United States
Coast Guard

I refer to your appeal dated February 12, 2016, on behalf of Trojan Technologies (Trojan). You requested a formal administrative appeal of the decision of the Marine Safety Center (MSC) denying Trojan's request for a testing alternative to be used in the Coast Guard's ballast water management system (BWMS) type approval process and Trojan's application for USCG type approval of the Trojan Marinex BWMS.¹

Based on this review, I hereby deny your appeal, affirming MSC's decision to deny Trojan's request for testing equivalency and type approval under 46 C.F.R. § 162.060-10. This matter and your appeal are quite technical and detailed, and the issues raised will be discussed in more detail in this letter.³ To briefly summarize, during the development of the ballast water regulations, the Coast Guard explicitly rejected the use of BWMS that "may act to make organisms unviable or unable to reproduce rather than killing or removing them." This policy decision to reject "viability" was based on the best scientific information available and was the most appropriate, environmentally protective decision within the Coast Guard's statutory mandate. MSC was therefore

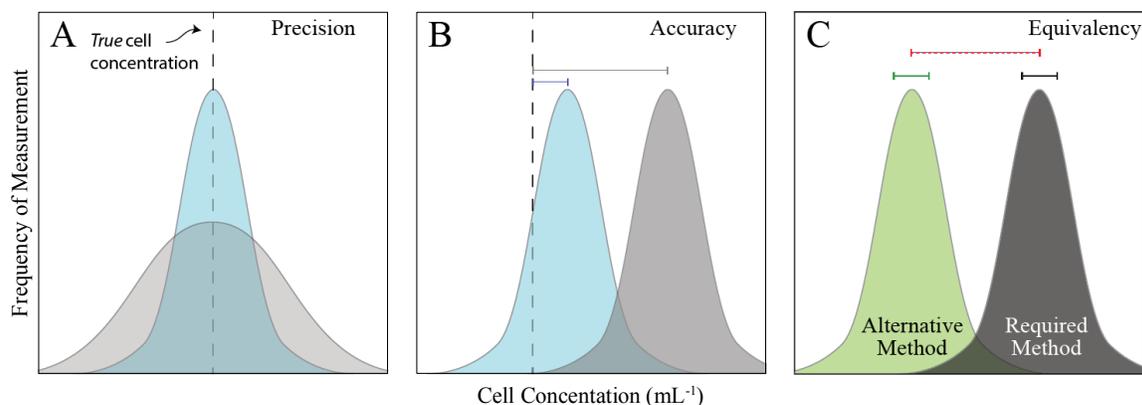
Before the validation is discussed, it is useful to consider two parameters that are commonly used to assess any method: precision and accuracy. If two methods are compared, the relationship between them can be illustrated in a conceptual figure (Figure 1), with the key metrics of precision (Figure 1A) and accuracy (Figure 1B) of the method relative to a known value (or a reference method). In a comparison between the Alternative and the Required Methods, the *true* cell concentration is not—and cannot be—known, so methods can be compared based upon their precision (the variation around the mean value of each method) and the difference between the two means (a proxy for accuracy, since the true value is not known) (Figure 1C). Ideally, the two methods will have a similarly small variation around the mean. Notably, the Alternative and Required Methods measure different metrics: the Alternative Method measures non-photosynthetic organisms by movement and autofluorescence, and it measures viable

phytoplankton amenable to culturing, whereas the Required Method measures phytoplankton and non-photosynthetic organisms in this size class by the examining active enzyme systems.

Figure 2. Comparison of the measurements of cell concentration of cultured algae performed using the Required Method and the Autotroph (Most Probable Number [MPN]) Method. Data are from Miller and Petri (2015 [Exp. 6]). The dotted line indicates a 1:1 (perfect) relationship between the methods.

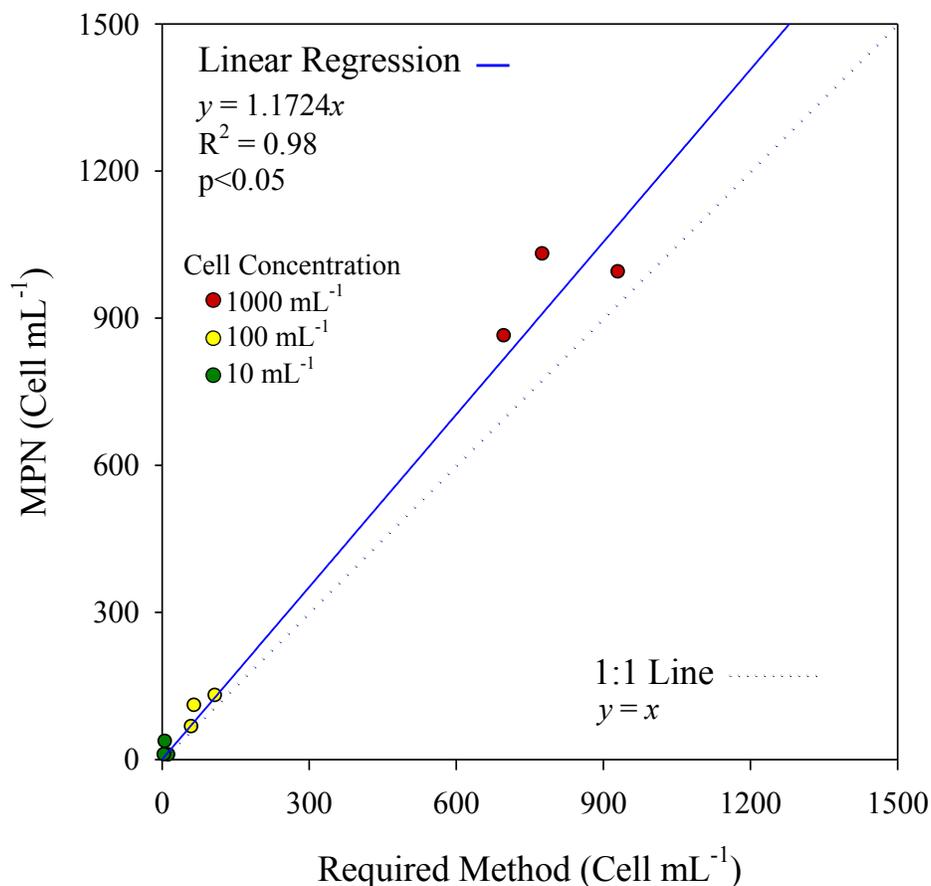
The data in Table 8 are plotted in Figure 2 and Figure 3, which were prepared for this Review. Figure 2 plots the mean cell concentration for the Required and Alternative Methods. Linear regression analysis was used to measure the strength of the relationship between the two approaches, and the best-fit line was plotted. In this case, there was a significant, positive, linear relationship between the two methods ($R^2 = 0.98$, $p < 0.05$). In Figure 3, the coefficients of variation (CV) of both methods were plotted. Here, no relationship was evident, although the CV for the Required Method was lower (<30%) than that of the Alternative Method (approximately 20-65%). In both figures, the statistical analyses were conducted using SigmaPlot. In sum, there was good agreement between the methods, but the precision of the Alternative Method was greater than that of the Required Method. Note that the term “Alternative Method” is not used in either figure, as the experiment’s results (from Table 8,

describing measurements of one cultured phytoplankter) were reported using the Autotroph Method only (not a combination of the Autotroph and Heterotroph Method).
